SPECTRO1-Scope: Changes after Software Update from SPECTRO1-Scope V2.10 to V3.0

This manual summarises the changes that were made with the software update from **SPECTRO1 V2.10** to **V3.0**.

Change 1:

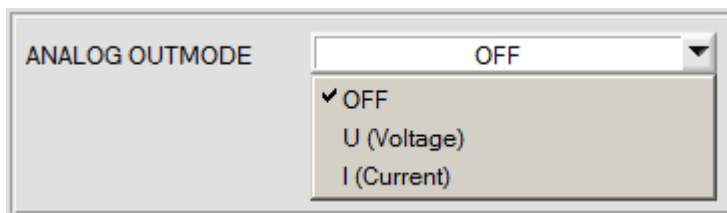
Under **ANALOG OUTMODE** the option **U+I** is no longer available. This means that starting from version 3.0 either a voltage of **0-10V** or a current of **4-20mA** can be output.
